Index 711-001 Pavement Markings

COMMENTS AND RESPONSES

LAST REVISION 11/01/24	REVISION	DESCRIPTION:	 FY 2025-26 STANDARD PLANS	PAVEMENT MARKINGS	INDEX 711-001	SHEET 4 of 13
---------------------------	----------	--------------	--	-------------------	------------------	------------------

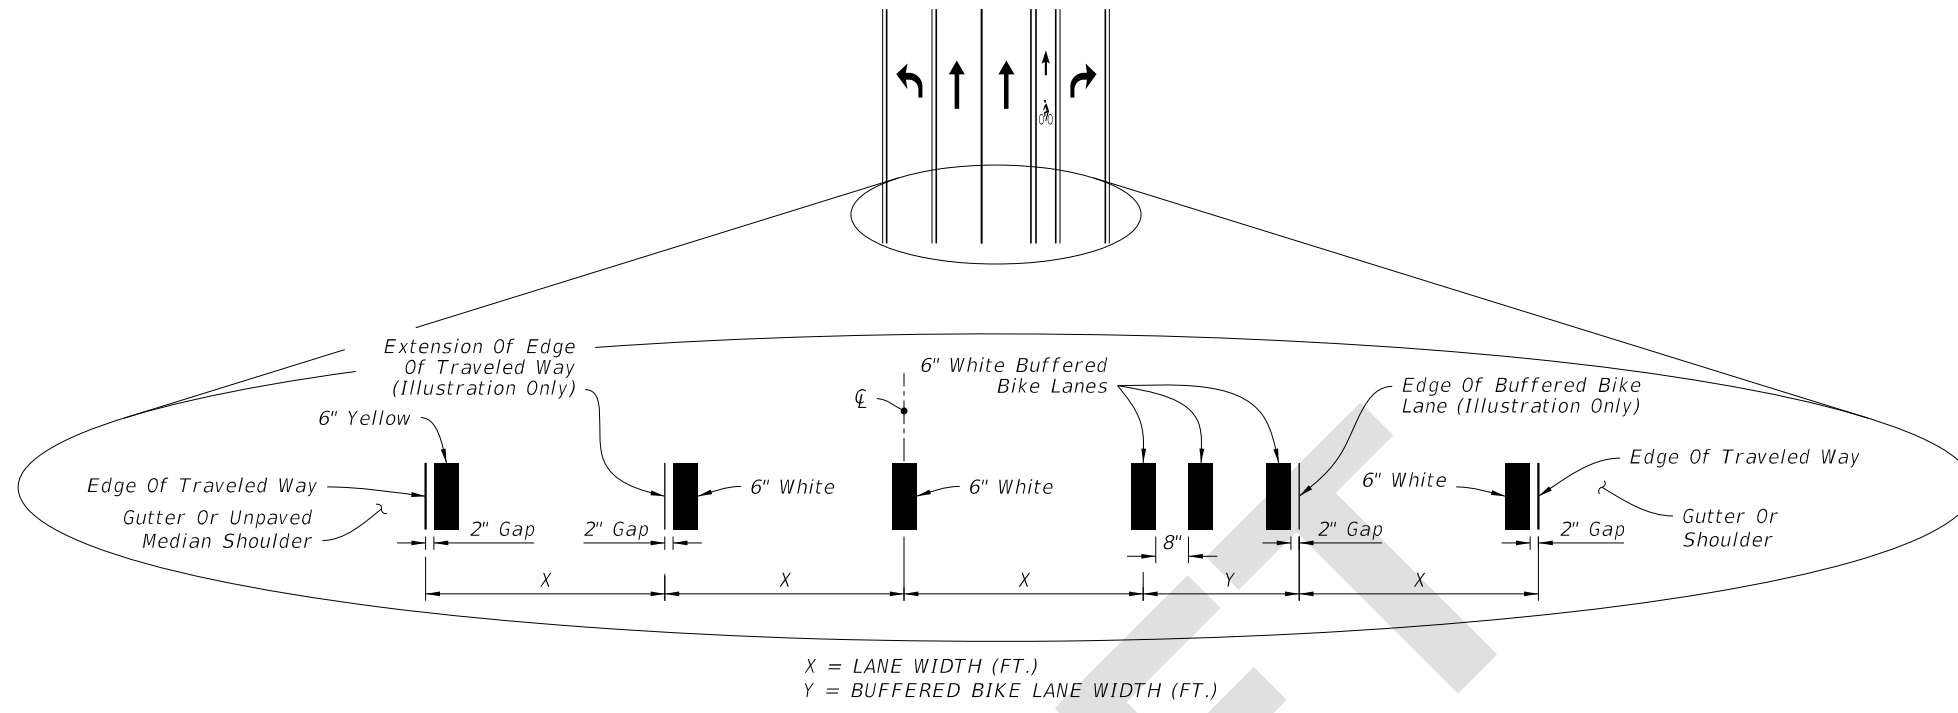
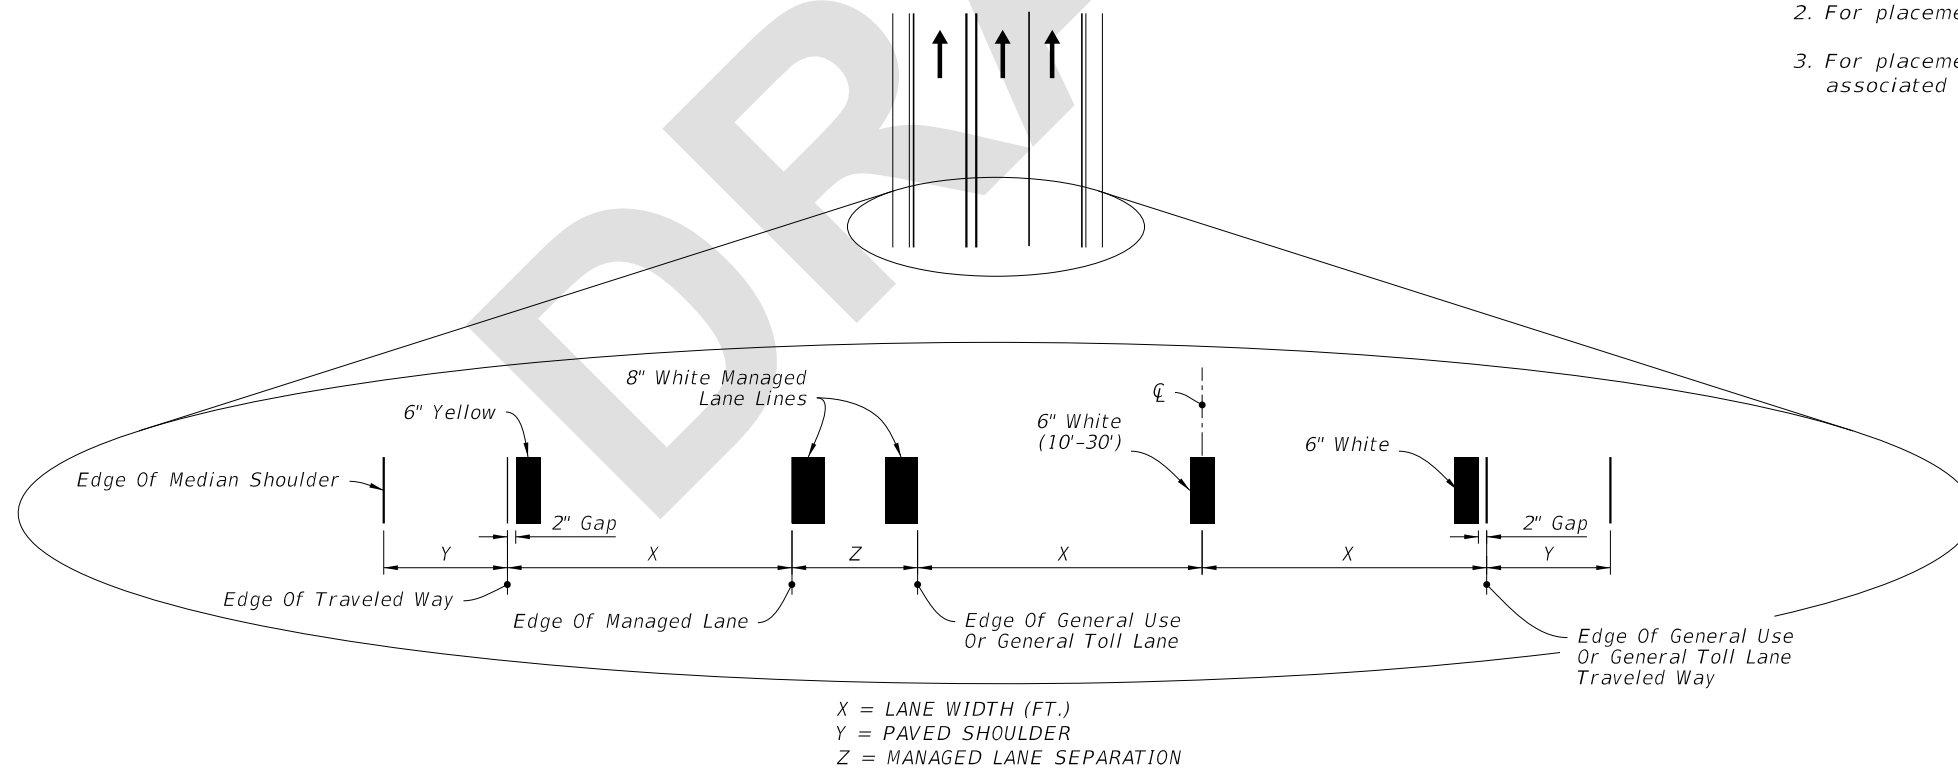
COMMENT: I agree with the proposed changes on the marked up sheets for clarifying the striping of the separation for managed lanes. It seems like there is room for the same clarification on some of the other details showing buffer striping for bike lanes. The double stripes being removed from the small circled detail for managed lanes could also be removed for the bike lane buffer for consistency.

COMMENT: On sheet 4 of 13 Note #3 refers to Managed Lane markers. These products are called tubular markers. Please change the words 'Managed Lane markers' to 'tubular markers'. Please contact me if you have any questions.

COMMENT: The terminology "managed lane marker" is inconsistent with the specification and APL products that identify "tubular markers."

RESPONSE: Thank you for the comment. The goal was to match the zoomed-out detail to the zoomed-in detail. We will look at these in more detail and update as necessary.

CHANGE MADE TO INDEX: Yes. Added double lines to Managed Lane Detail.

RESPONSE: Thank you for the comment. The note has been revised as requested.

CHANGE MADE TO INDEX: Yes. Revised the note to “tubular markers.”

RESPONSE: Thank you for the comment. Managed lane markers will be revised to Tubular Markers.

CHANGE MADE TO INDEX: Yes. Revised the note to “tubular markers.”
